PUD 07-000006

PLANNING DEPARTMENT

PLANNED UNIT DEVELOPMENT PERMIT NO. 07-000006 (PUD 07-000006)

TMK: 7-3-054: 010 & 043 (formerly 7-3-005: 012); Kalaoa 4th, North Kona, Hawaii

Figure 11: Special Paving

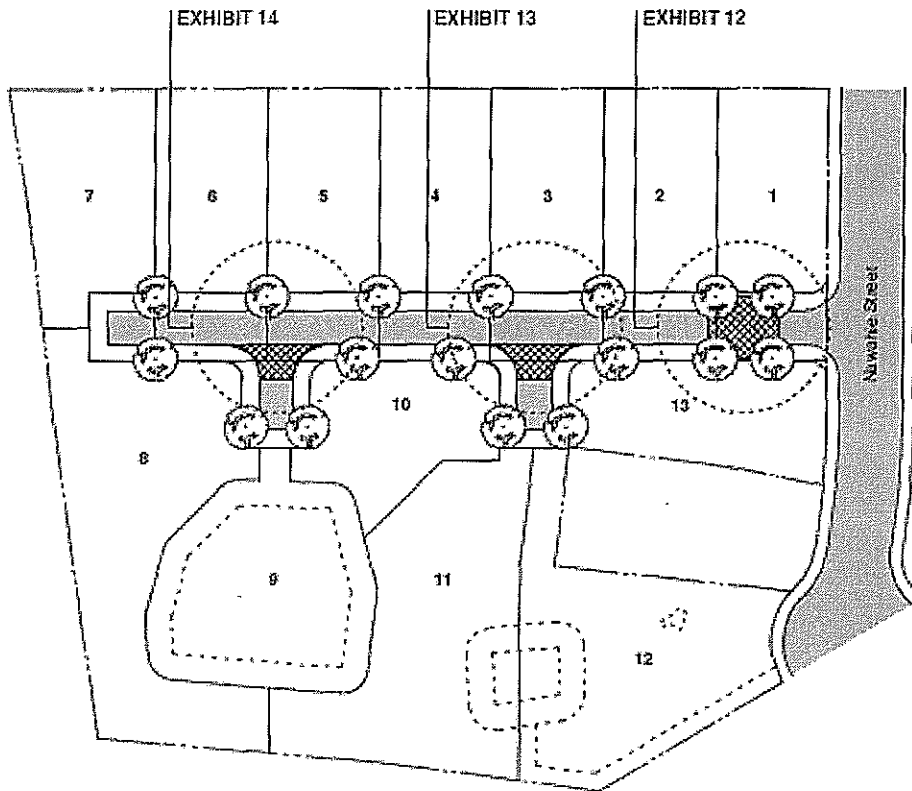
- **Special Pavement treatment within roadway easement (Figure 11)**. We approve of the Applicant's request to install special paving and street trees at the subdivision entrance to not only define the entrance to the subdivision, but also to provide an area for a mail kiosk. The special paving may also be used at the common access driveways located throughout the subdivision. The type of special paving and the location of vertical elements, such as the street trees and mail kiosk, must meet with the approval of the Department of Public Works to ensure that its location does not inhibit larger vehicles like buses or fire trucks.
